Access Compliance Report

Public Rights-of-Way

Intersection ID: 12066	Main Street: WEYLAND_AV	Cross Street: MARLOWE_AV	Location: NW
ADA ID: 05E50B2327A3	Ramp Type: PerpDiag	Initial Pass/Fail: Fail	Overall Compliance: No
Codes/Mitigation Info/Possible Solution		Field Measurements/Component Compliance

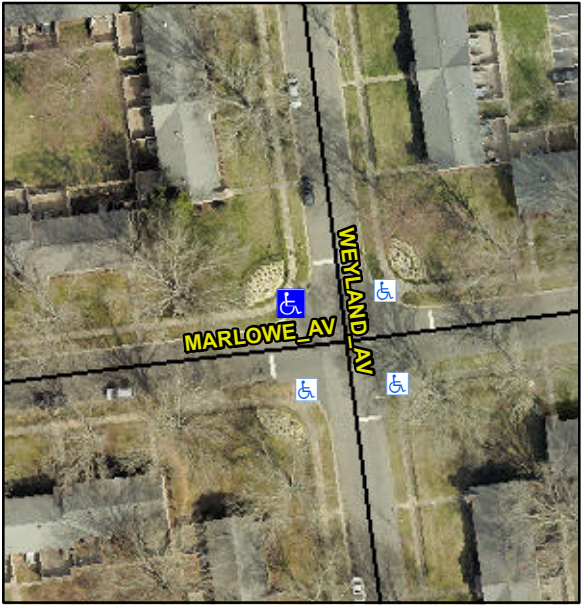
Possible Solutions:	Compliance	Description	Data	Compliance	Description	Data
	Remove & Replace Curb Ramp With Two New Directional Ramps or Equivalent.	N/A	Ramp Length (in)	72.5	No	Ramp Slope (%)	9.5
<p>Surveyor Notes:</p> <p>N/A</p> <p>PROW/ADA:</p> <p>Not Found, R304.5.1, R304.2.2, R304.5.3</p>		No	Ramp Width (in)	42.5	No	Ramp XSlope (%)	3.1
		N/A	Flare Type LT	N/A	N/A	Flare Type RT	N/A
		N/A	Flare Slope LT (%)	N/A	N/A	Flare Slope RT (%)	N/A
		N/A	Flare Traversable LT?	N/A	N/A	Flare Traversable RT?	N/A
		N/A	Landing Length (in)	N/A	N/A	DWS Provided?	N/A
		N/A	Landing Width (in)	N/A	N/A	DWS Contrast?	N/A
		N/A	Landing Slope (%)	N/A	N/A	DWS Length (in)	N/A
		N/A	Landing X Slope (%)	N/A	N/A	DWS Full Width?	N/A
		N/A	Landing Curb? (Y/N)	N/A	N/A	DWS Offset (in)	N/A
		N/A	Shared Landing?	N/A			
		N/A	Gutter Ponding?	N/A	N/A	Gutter Slope (%)	N/A
		N/A	Gutter Lip Ht (in)	N/A	N/A	Gutter X Slope (%)	N/A
		N/A	Painted X Walk1?	No	N/A	Painted X Walk2?	No

X Walk 1 Direction	To S		X Walk 2 Direction	To E
		N/A	X Walk 1 Width (in)	N/A	N/A	X Walk 2 Width (in)	N/A
			X Walk 1 Slope (%)	2.6		X Walk 2 Slope (%)	2.4
			X Walk 1 X Slope (%)	1.9		X Walk 2 X Slope (%)	0.2
		N/A	Ramp inside XWalk1?	N/A	N/A	Ramp inside XWalk2?	N/A
			Road Slope (%)	1.3	N/A	Clear Space?	N/A
			Road X Slope (%)	3.1	N/A	Clear Space to XWalk (in)	N/A
		N/A	Any Obstructions?	N/A	N/A	Storm Grate/Utility Hazard?	N/A
			Obstruction Type			Storm Grate/Utility Type	
				N/A			N/A
					Yes	Surface Condition? (G/P)	Good
Total Cost:		\$	3200.00
